UNITED STATES PATENT AND TRADEMARK OFFICE

APPLICATION NO.	FILING DATE	FIRST NAMED INVENTOR	ATTORNEY DOCKET NO.	CONFIRMATION NO.
10/785,984	02/26/2004	Hiroshi Yamauchi	500.43535X00	2679
20457 7590 01/17/2007 ANTONELLI, TERRY, STOUT & KRAUS, LLP 1300 NORTH SEVENTEENTH STREET SUITE 1800 ARLINGTON, VA 22209-3873			EXAMINER CANTELMO, GREGG	
			ART UNIT 1745	PAPER NUMBER
SHORTENED STATUTORY PERIOD OF RESPONSE			MAIL DATE	DELIVERY MODE
3 MONTHS			01/17/2007	PAPER

Office Action Summary

DETAILED ACTION

FIG. 7

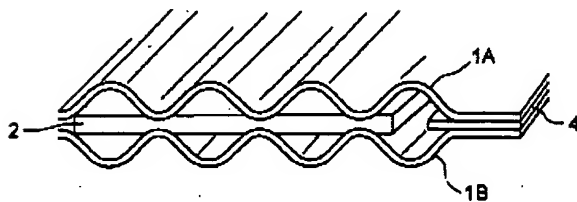
3. Figure 7 should be designated by a legend such as --Prior Art-- because only that which is old is illustrated. See MPEP § 608.02(g). Corrected drawings in compliance with 37 CFR 1.121(d) are required in reply to the Office action to avoid abandonment of the application. The replacement sheet(s) should be labeled "Replacement Sheet" in the page header (as per 37 CFR 1.84(c)) so as not to obstruct any portion of the drawing figures. If the changes are not accepted by the examiner, the applicant will be notified and informed of any required corrective action in the next Office action. The objection to the drawings will not be held in abeyance.

Admitted prior art Fig. 7 discloses a cooling section of a fuel cell comprising a pair of metallic separators at least one of which has corrugated passages; and a gasket 4 in the portion other than the passage plane of the passages (Fig. 7 as applied to claims 1 and 7).

The difference between the admitted prior art Fig. 7 and claims 1 and 7 is that Fig. 7 does not teach of providing an elastic and/or compressive and electroconductive intermediate between the passage planes of the two separator plates of the cooling section.

FIG. 1

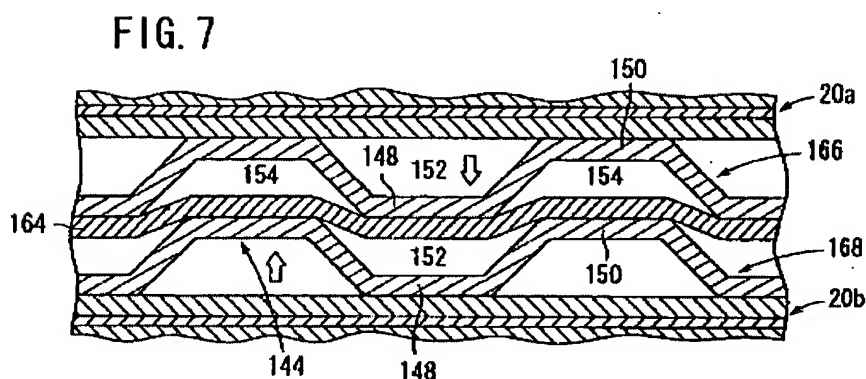
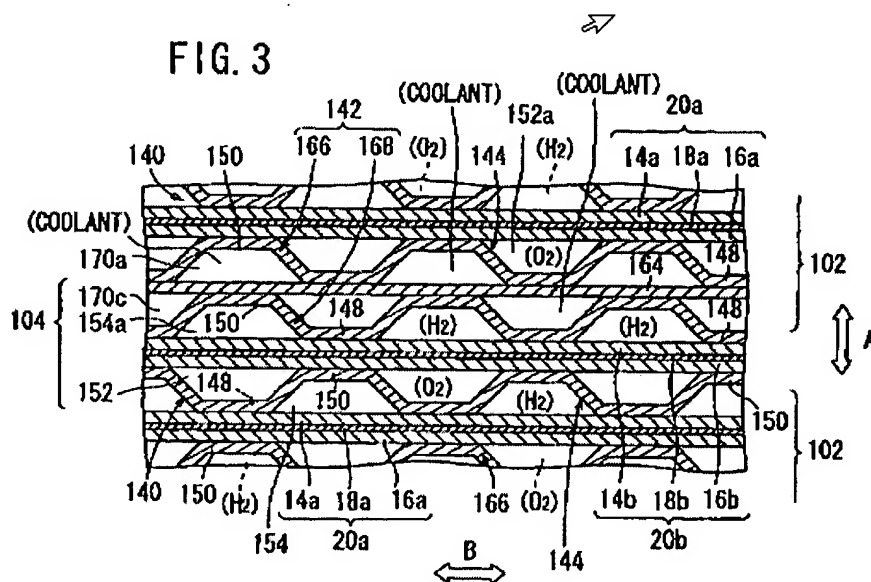
- c. Claims 1-9 require that the gasket is provided in a portion other than the passage planes. However this arrangement is not particularly clear. According to Fig. 2, the Gasket 4 extends into at least one passage of the coolant passages and thus would appear to be within a passage plane. Furthermore it is unclear as what the claims mean by the term passage plane. Therefore the arrangement of the gasket relative to the passage planes is not clearly defined and held to be indefinite.

Comparative to the instant applications inventive concept in Fig. 1:

FIG. 7

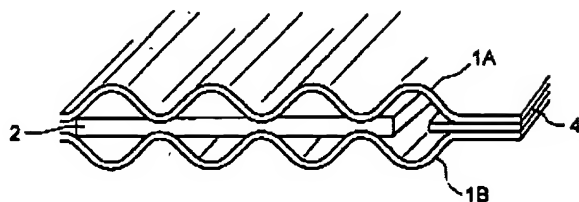
Admitted prior art Fig. 7 discloses a cooling section of a fuel cell comprising a pair of metallic separators at least one of which has corrugated passages; and a gasket 4 in the portion other than the passage plane of the passages (Fig. 7 as applied to claims 1 and 7).

The differences between the admitted prior art Fig. 7 and claims 1 and 7-8 are that Fig. 7 does not teach of providing an elastic and/or compressive and electroconductive intermediate between the passage planes of the two separator plates of the cooling section (claims 1 and 7) or of the intermediate sheet having openings in portions which are not in direct contact with the separator for cooling (claim 8).

Figure 3

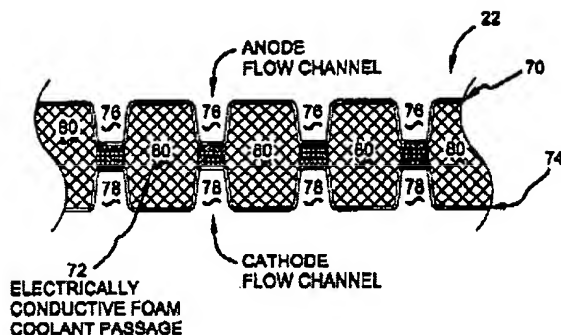
Alternatively Brady discloses providing an electrically conductive foam between adjacent separator plates 70 and 74. The foam 80 is both electroconductive and, as a porous foam, also compressible or elastic (Fig. 3 and abstract as applied to claims 1 and 7).

Furthermore the foam sections include opening portions therein which are not in direct contact with the separator and provide for defining cooling passages in the foam (Fig. 3 as applied to claim 8).

The motivation for using the foam is that it provides for regions of high density to improve the conductive nature of the multilayer separator arrangement and regions of low density which have adequate cooling space and well as a conductive mesh network within the coolant spaces 80.

Figure 3

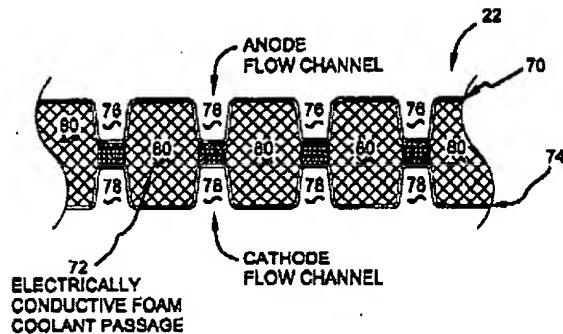
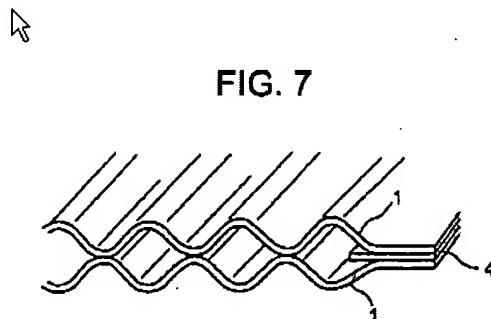
Brady discloses providing an electrically conductive foam between adjacent separator plates 70 and 74. The foam 80 is both electroconductive and, as a porous foam, also compressible or elastic (Fig. 3 and abstract as applied to claims 1 and 7).

Brady discloses a fuel cell stack comprising electrolyte membrane electrodes, gas diffusion layers and a metallic separator (Fig. 1 and col. 3, ll. 5-60) where the separator includes corrugated metal foils 70 and 74 which is further provided with providing an electrically conductive foam 80 between adjacent separator plates 70 and 74. The foam 80 is both electroconductive and, as a porous foam, also compressible or elastic (Fig. 3 and abstract as applied to claim 2).

Furthermore the foam sections include opening portions therein which are not in direct contact with the separator and provide for defining cooling passages in the foam (Fig. 3 as applied to claims 3 and 8).

The foam can be a metal foam, graphite foam or carbon foam. The graphite and carbon foams are equivalent to the broader carbon paper, carbon cloth and graphite sheet as claimed (as applied to claims 4 and 9).
